April 25, 2019

**SUBJECT: Response to PA DEP and East Rockhill Township Comments  
Qualitative Geologic Survey Sampling Plan  
Rock Hill Quarry, SMP No. 7974SM1  
East Rockhill Township, Bucks County, PA  
EARTHRES Project No. 061003.051**

**Drawing D-1: Bench Face Mapping**

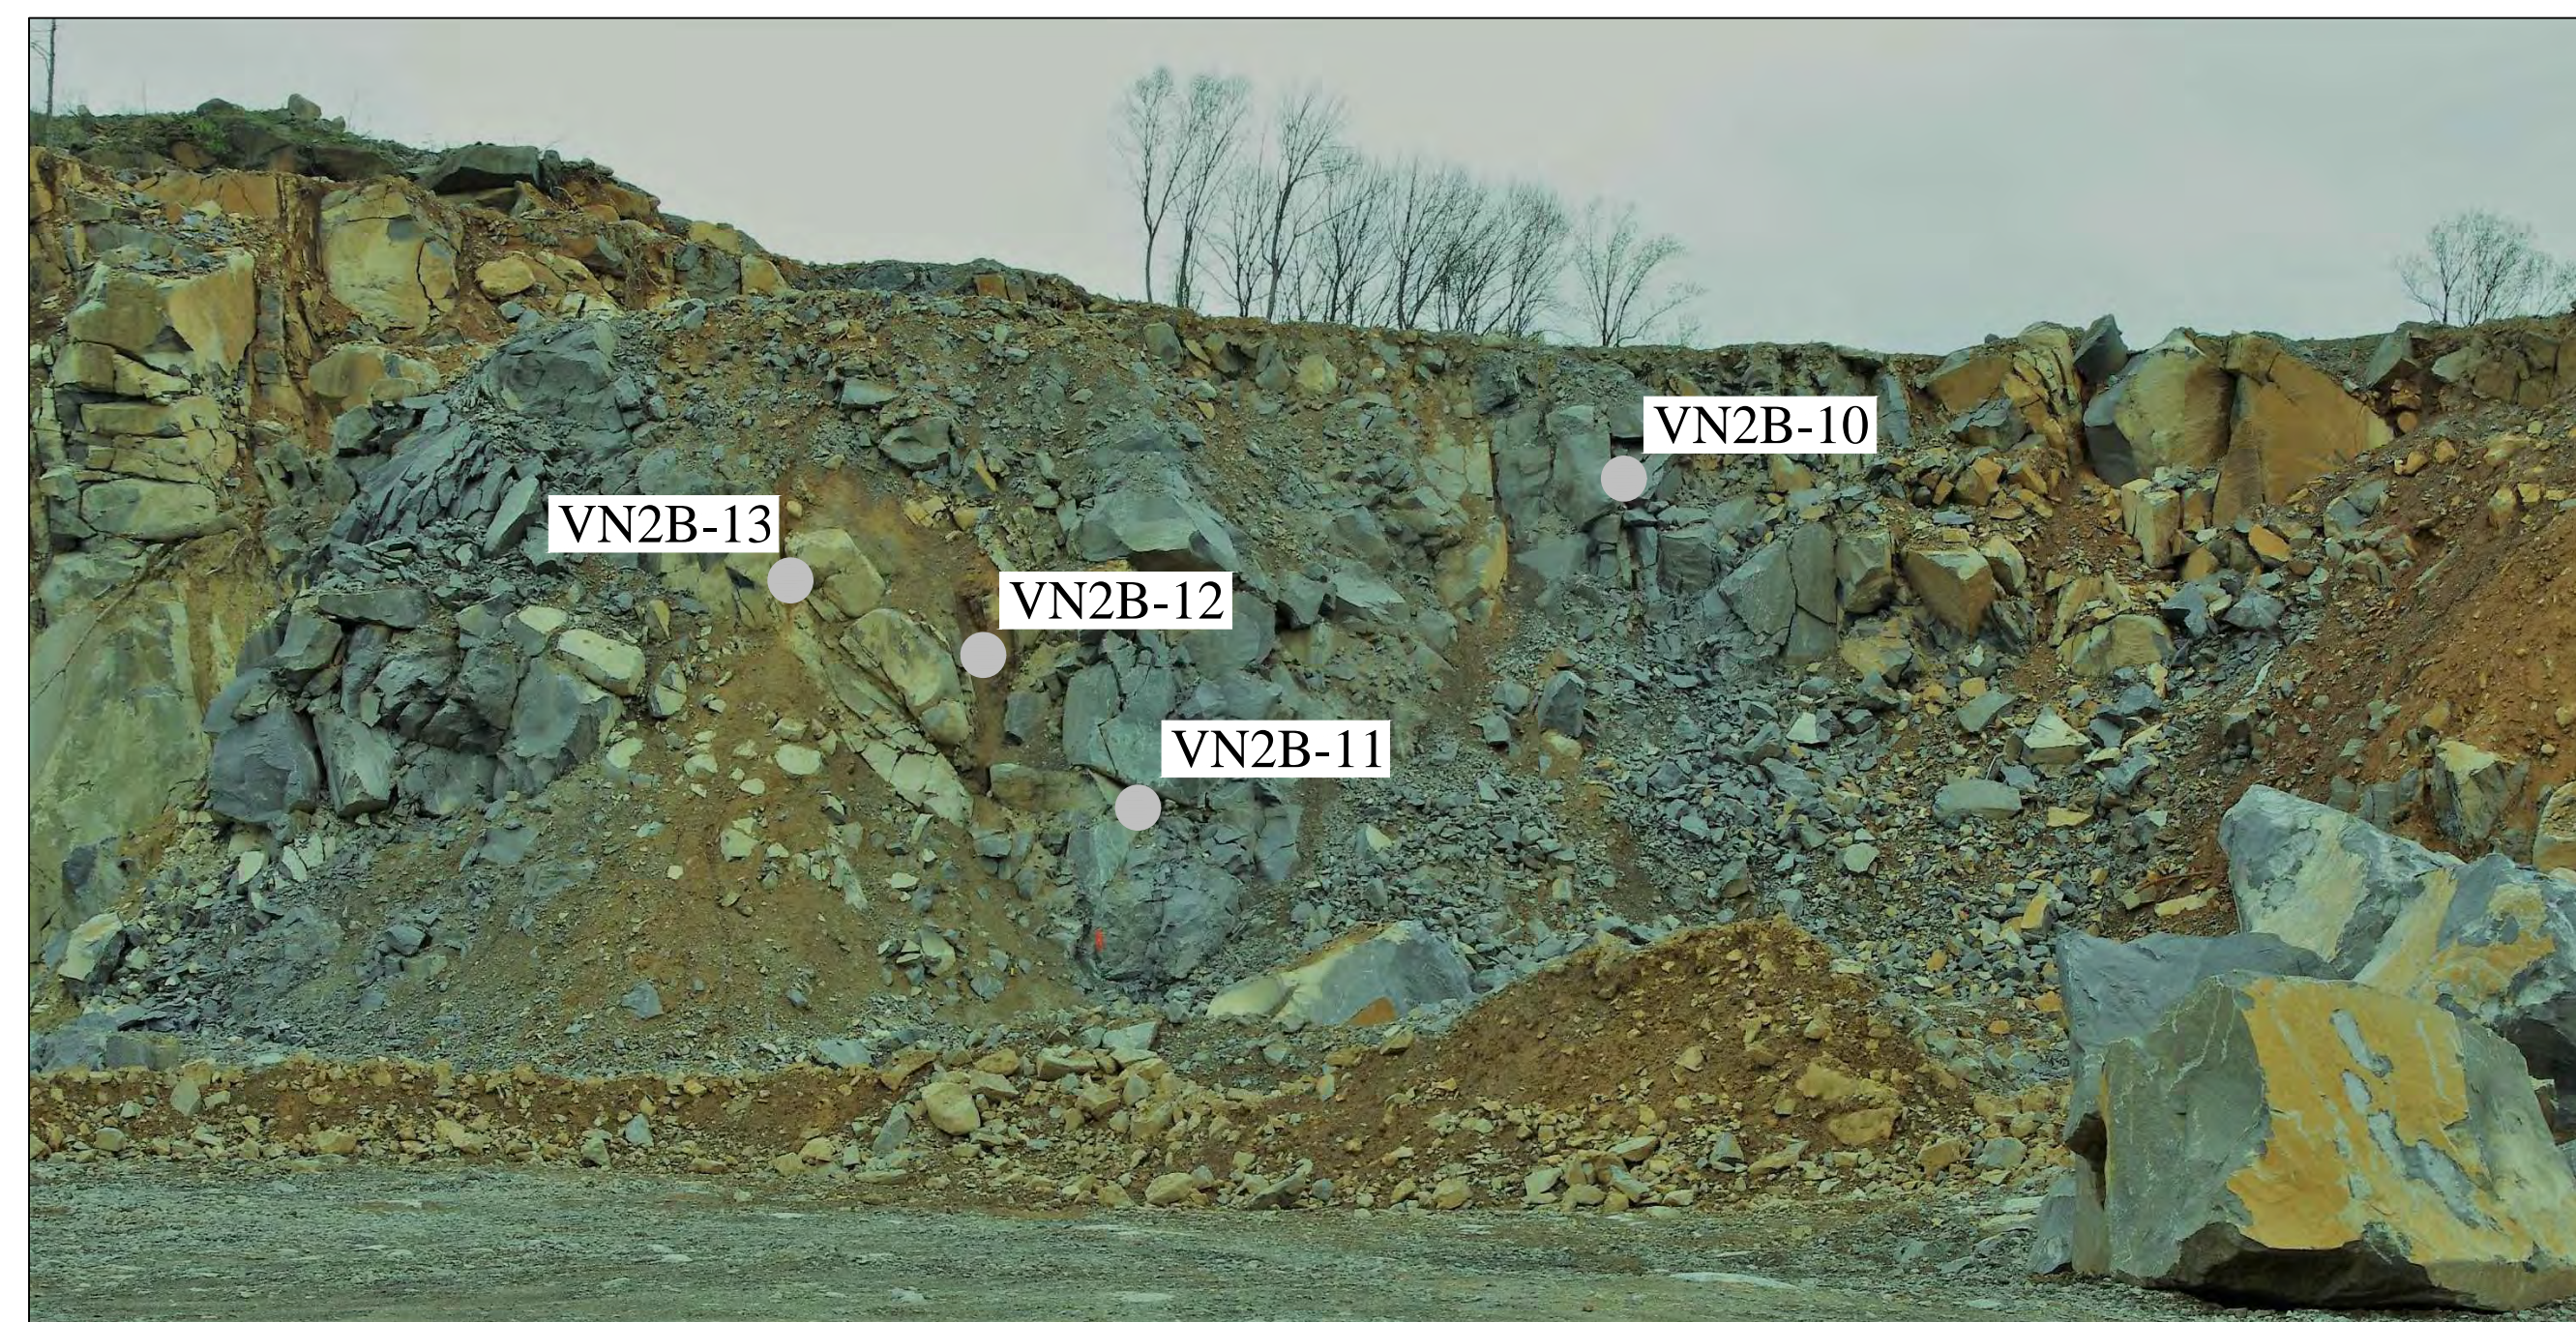
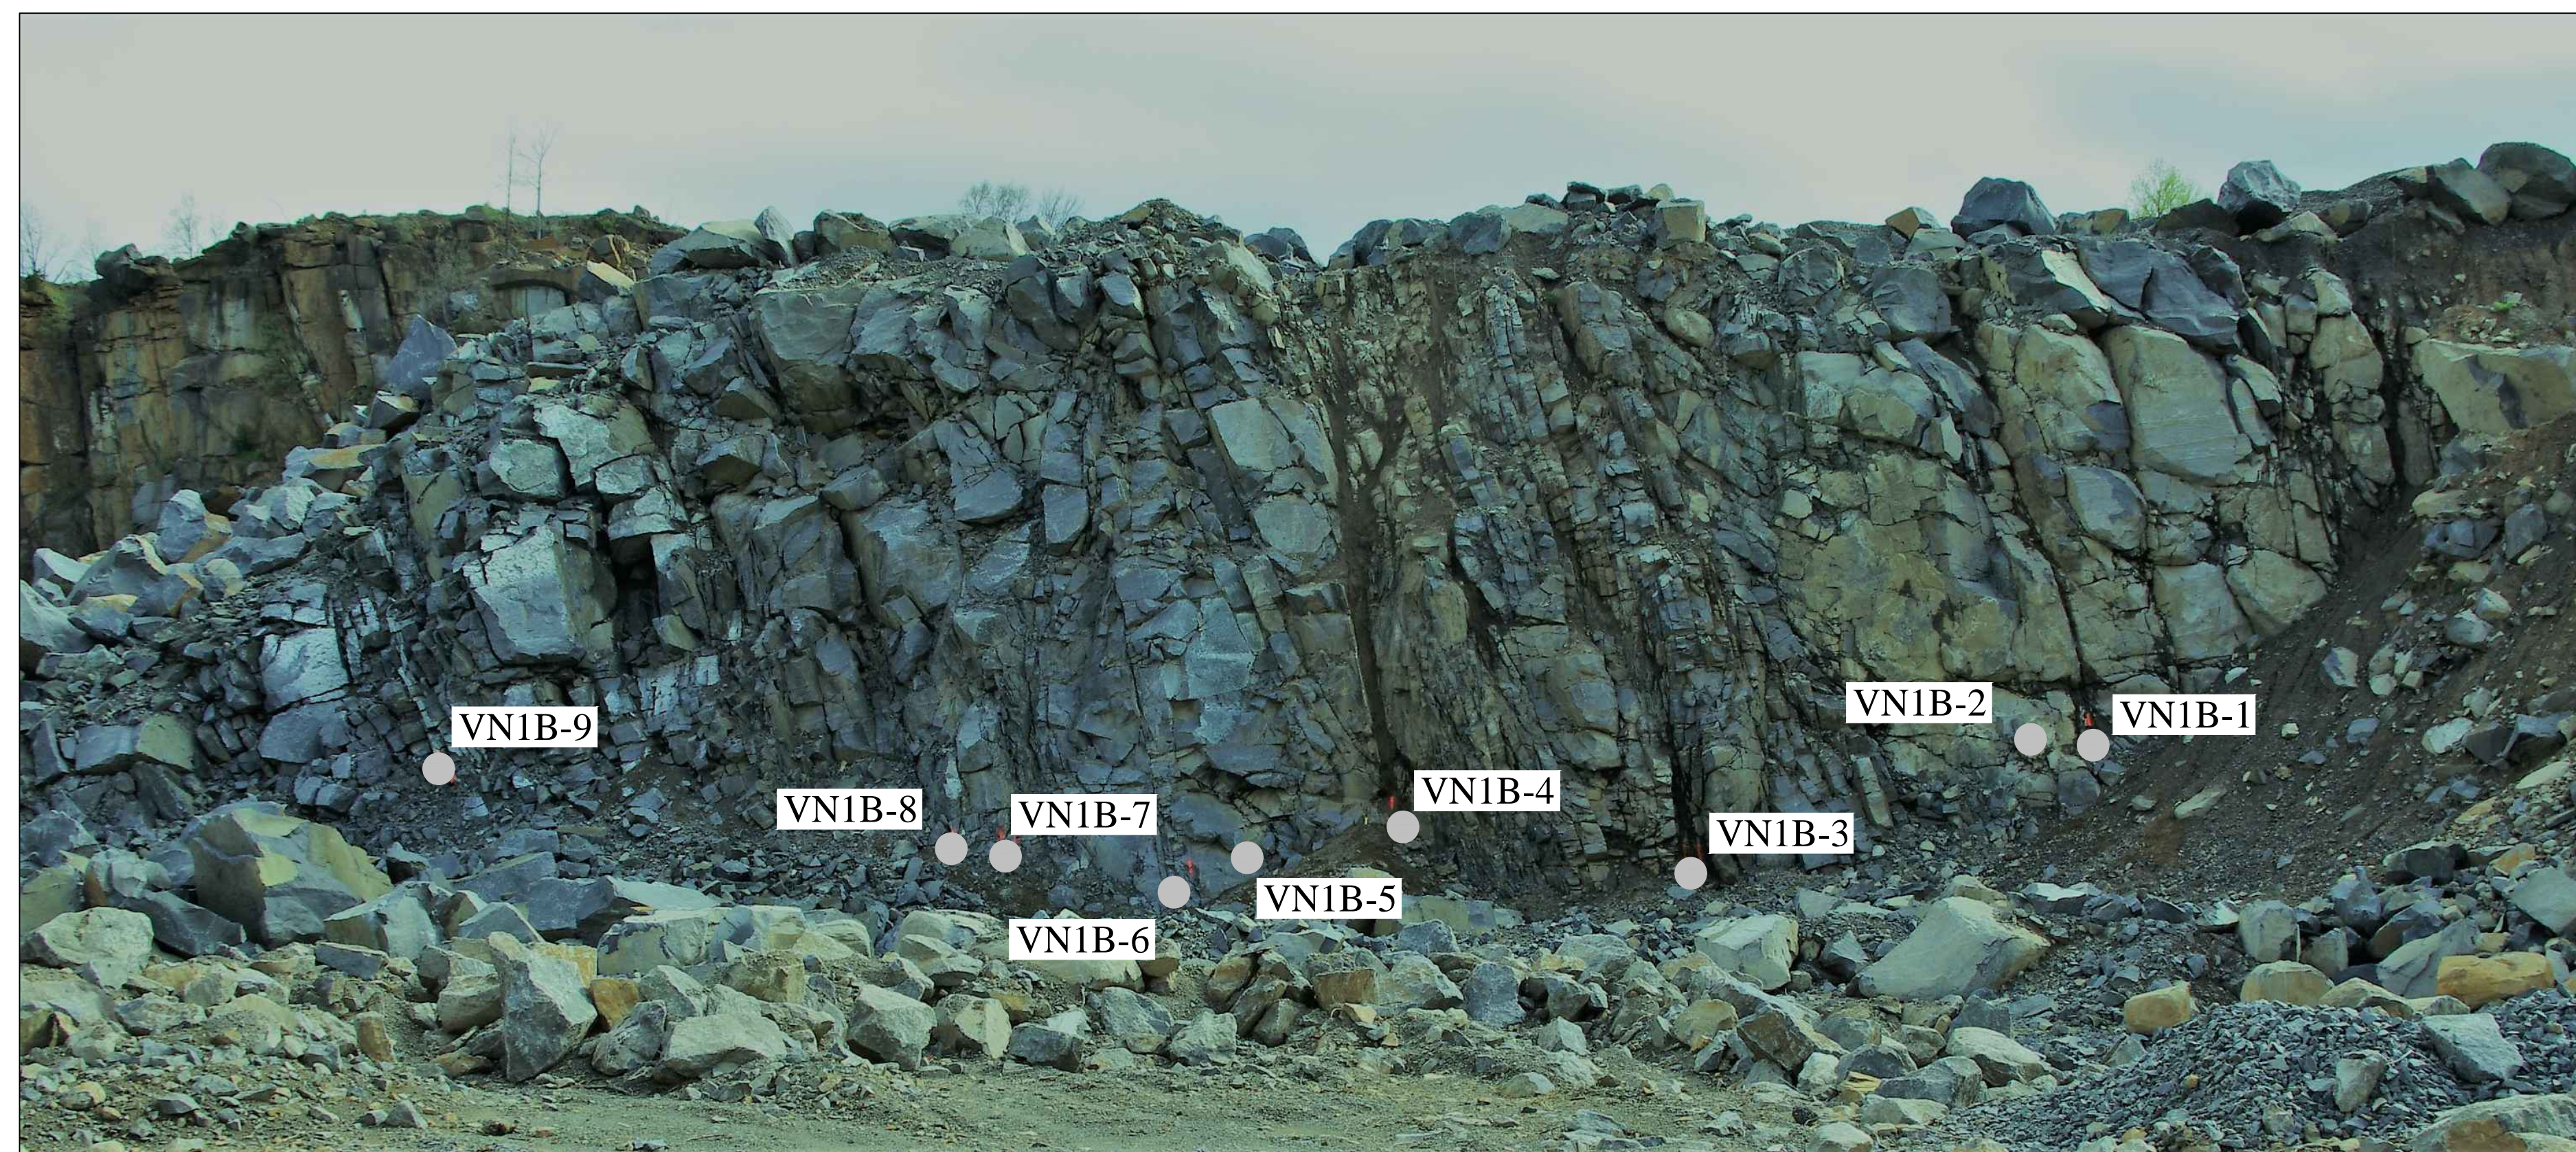
- 3) **Both the NSSGA Guide and the Aggregates Handbook encourage a proper mapping effort as part of the investigations described in these documents. The Department has notified Hanson during the December and February meetings and during other discussions that it expects the veins at the Rock Hill quarry to be mapped and described. To date, the Department has not received any information from Hanson regarding the mapping effort or its results. Results from a comprehensive mapping effort could effectively answer the Department's comments #1, #3 and #4 regarding the core drilling as well as East Rockhill Township's comment #4.**

*EARTHRES and Hanson professional geologists were onsite Monday April 22, 2019 to map mineral vein features exposed on the benches proposed for drilling and ultimately mining activities. The results of that effort are attached to these responses. Overall, the features found were trending as expected provided the geological environment, the geological evaluation contained in our report of January 2018, our QGSSP dated April 3, 2019 and our prior comment responses of April 17 and 19, 2019. Additional detailed responses to your questions are provided in the following comment responses and in the attached documents.*

*Please find the attached table that includes the geological data (i.e. strike, dip, and description) of the bench-face features found during the on-site mapping completed on April 22, 2019. The data was statistically analyzed using Rockworks software to determine the average strike and dip of the features. A stereonet plot of the data is attached and indicates an average strike of the vein features to be N45E, dipping steeply at 78 degrees SE. The average feature strike is in agreement with the regional strike direction indicated the QGSSP submitted on April 3, 2019. Also provided herein are photographs of the mapped features that are keyed to their locations on each bench (Drawing D-1: Bench Face Mapping). The data was further plotted in 3D using AutoCAD to evaluate feature trends with respect to the proposed drilling locations.*

## **Figure 1 – Geologic Features and Coring Location Plan**

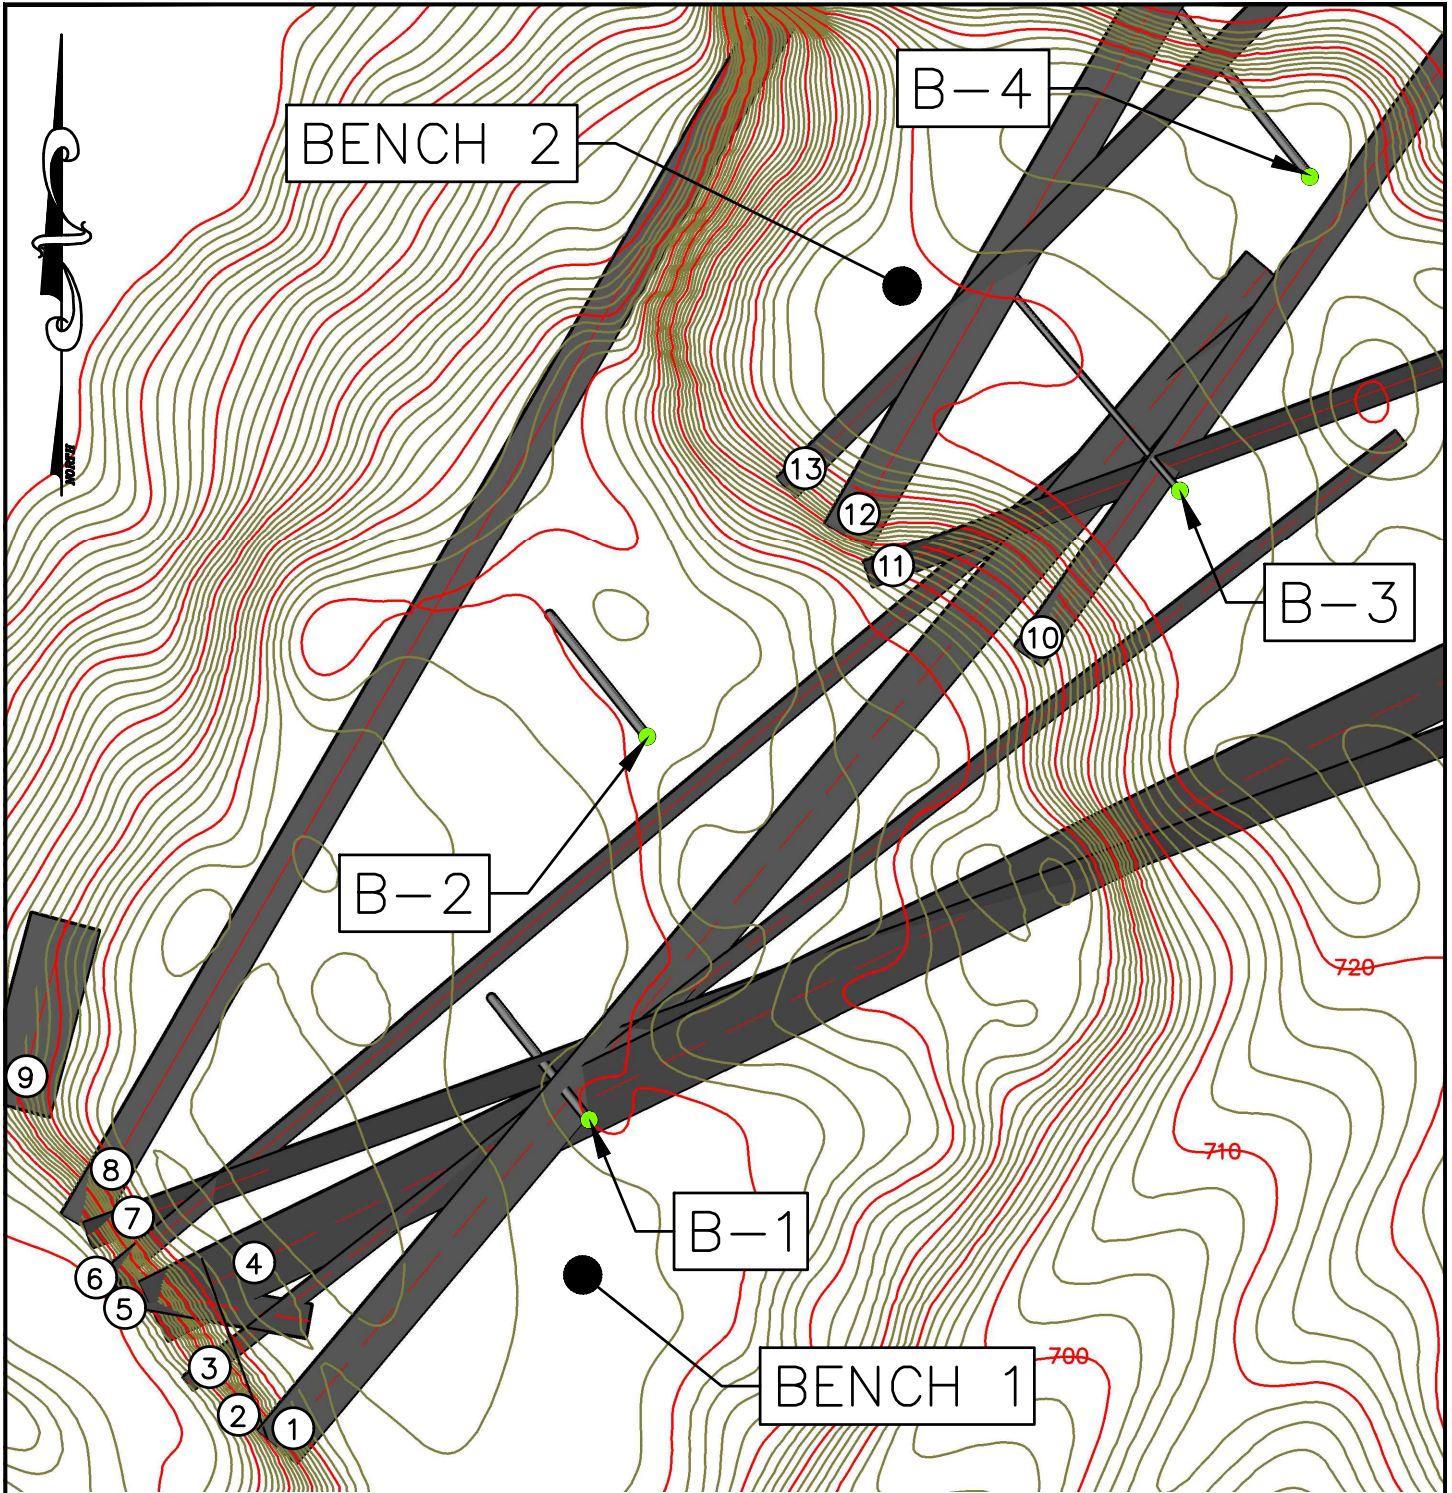
4. **Rock Coring and Sampling Frequency:** While the amount of material in the "planned mining area" is not described in the Plan, the number and spacing of the rock cores shown on Figure 1B is insufficient. The cores are spaced approximately 75 to 250 feet apart, and many asbestos-containing mineral veins could exist between the cores and would therefore not be accounted for in the survey.

*The proposed coring locations and mapped features are shown in map view on the attached Figure 1. The cores will be drilled on an approximately 30-degree angle from vertical with an azimuth of approximately N45W. The drilling direction is oriented perpendicular to geological strike and is dipping opposite of the found features in order to intercept as many potential features as practical. The core borings will be advanced to an elevation of approximately 585 feet above mean sea level (MSL), which is approximately equivalent to the current water level in the Quarry pit.*

*Core Borings 1 (B-1) and B-2 are proposed to be located on Bench 1. The B-1 location was chosen to intercept the Veins 1, 3, 4, and 7. Coring B-2 is proposed in an area where face-mapped features are not projected to be present, thus providing additional geological coverage.*

*Core Borings B-3 and B-4 are proposed to be located on Bench 2. The B-3 location was chosen to intercept the Veins 1, 6, 10 and 11. B-4 is proposed to intercept Veins 12 and 13 and provide additional geological coverage in an area where face-mapped features are not projected to be present.*

*Please see our detailed response to the Department's Comment #3. The drilling locations were adjusted as described based upon the found geological features. If the results indicate the presence of naturally occurring asbestos-containing mineral veins, additional sampling may be proposed.*
